Bronxchester RFP Addendum 1
RFP issue date: March 29, 2013
Addendum 1 issue date: May 7, 2013

Part C: MODIFIED DESIGN GUIDELINES FOR BRONXCHESTER RFP

D. Map identifying Sewer Easement – Block 2361, Lot 25 – Enclosed is a Map identifying the Sewer Easement on Block 2361, Lot 25 from the Bronx Topography Unit.

PLAN NO. 11919

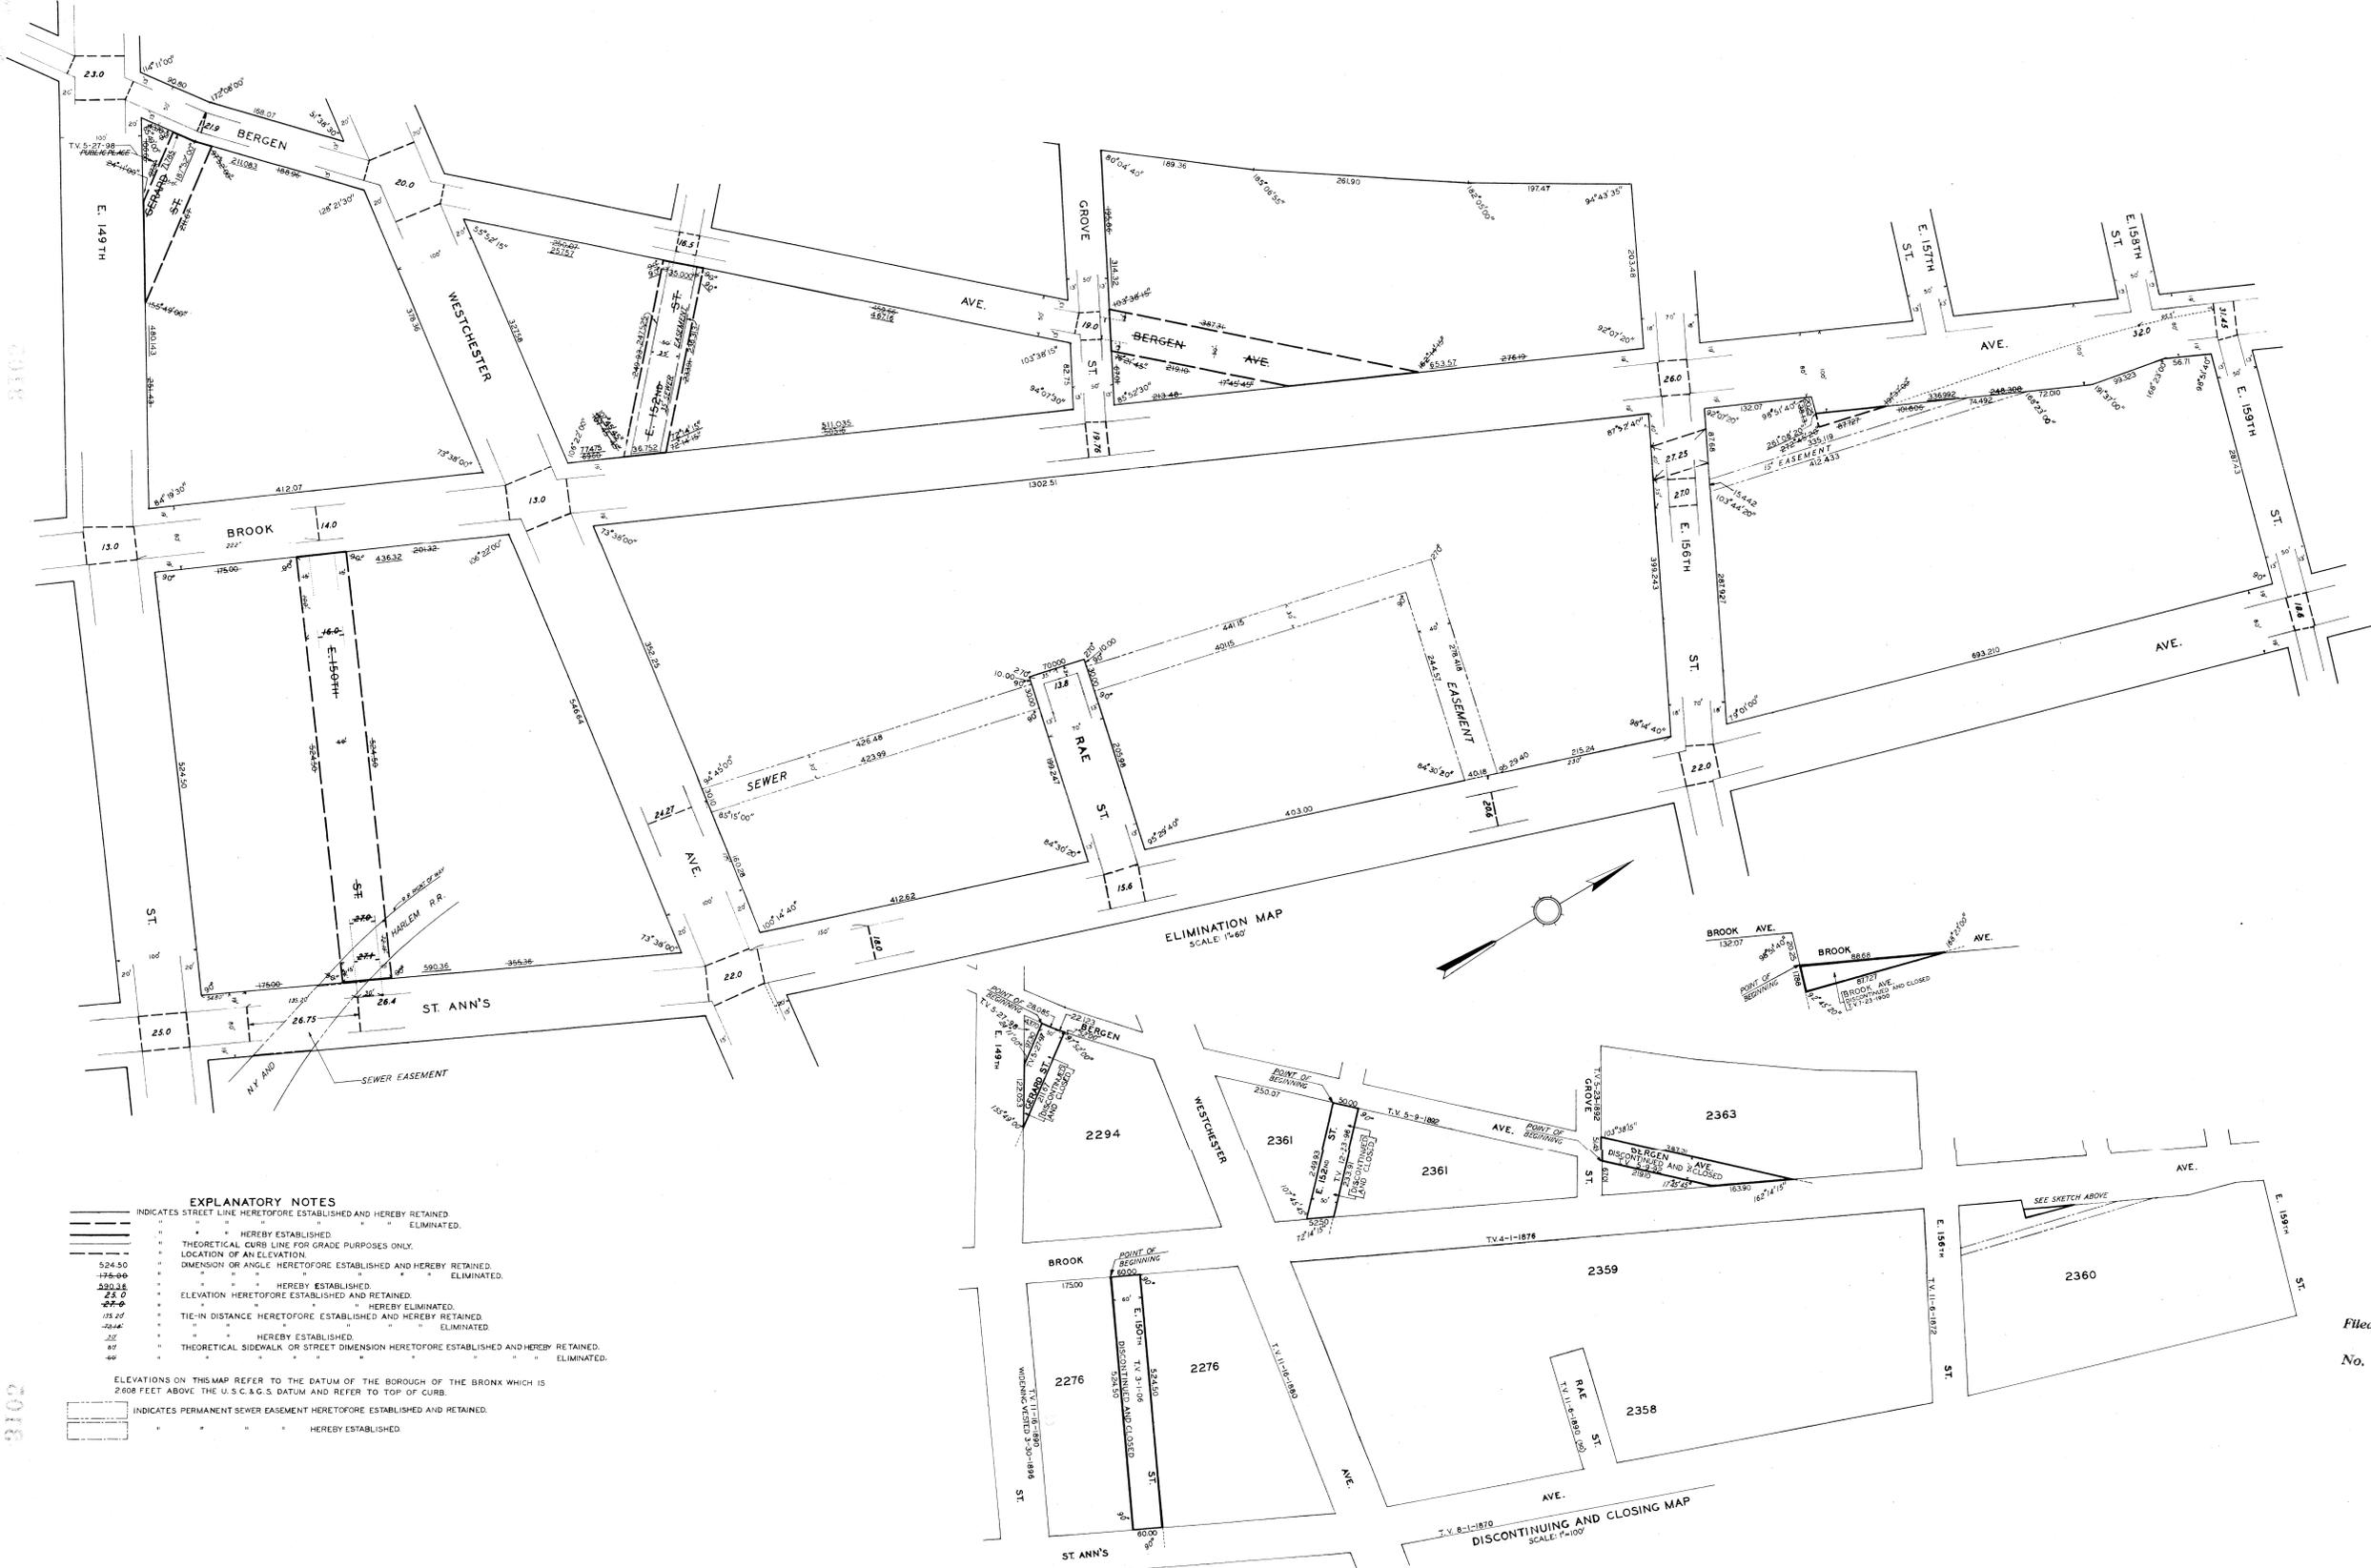
Question 4: The RFP talks about "creative treatment" on Block 2361/Lot 25, please explain what this means and if you are looking for something specific?

Question 5: Is a survey available for distribution for Block 2361/Lot 25?

Question 7: Can you build over the easement on Lot 25 and to what height?

Answer 4: We are not looking for a specific treatment, but would like a thoughtful design approach to the easement and its surrounding area. We wanted to ensure that the easement and its surrounding area are activated.

Answer 5: No, a survey is not available for distribution. Though the City Tax Map does not identify an easement, a Map identifying the Sewer Easement on Block 2361/Lot 25 is attached as Part D of this Addendum. The Map is from the Bronx Topography Unit.

Answer 7: One may not directly build in the easement on Lot 25. Building in the area above the easement (e.g. cantilevered over the street bed) is permitted as long as the height of the structure allows the Department of Environmental Protection (DEP) to adequately access the utility easement. DEP needs a height clearance in the 20-25' range.
